Docket Nos. 50-348  
and 50-364

SUBJECT: PAGE CORRECTION FOR LICENSE AMENDMENT NOS. 53 AND 44 -  
JOSEPH M. FARLEY NUCLEAR PLANT UNITS 1 AND 2

Figure 6.2-1 Offsite Organization for Facility Management and Technical Support

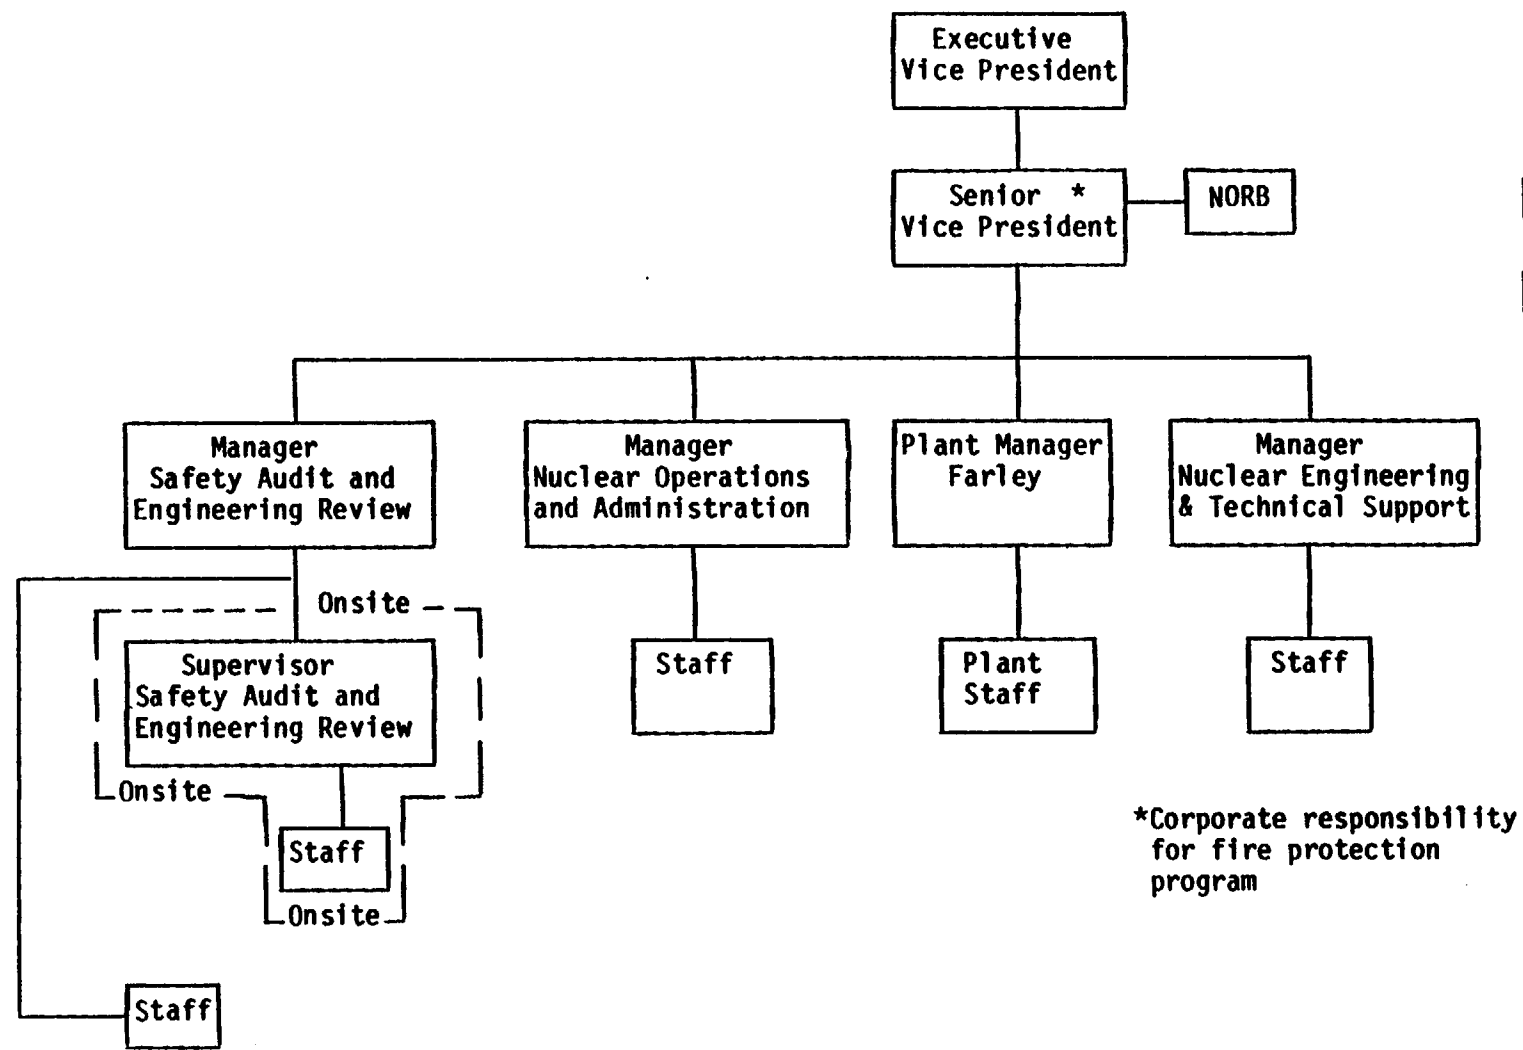
By telecon on December 10, 1984, your staff advised us that page 6-2 of the subject license amendments contained an error. Page 6-2, Figure 6.2-1 Offsite Organization for Facility Management and Technical Support, for Units 1 and 2 Technical Specifications show the amendment numbers at the bottom of the page to be reversed. For Unit 1 page 6-2 should be identified as Amendment No. 53 and for Unit 2 page 6-2 should be Amendment No. 44. These figures are identical in all other respects.

A "Corrected Page" for each unit is enclosed for use. We regret any inconvenience this administrative error may have caused.
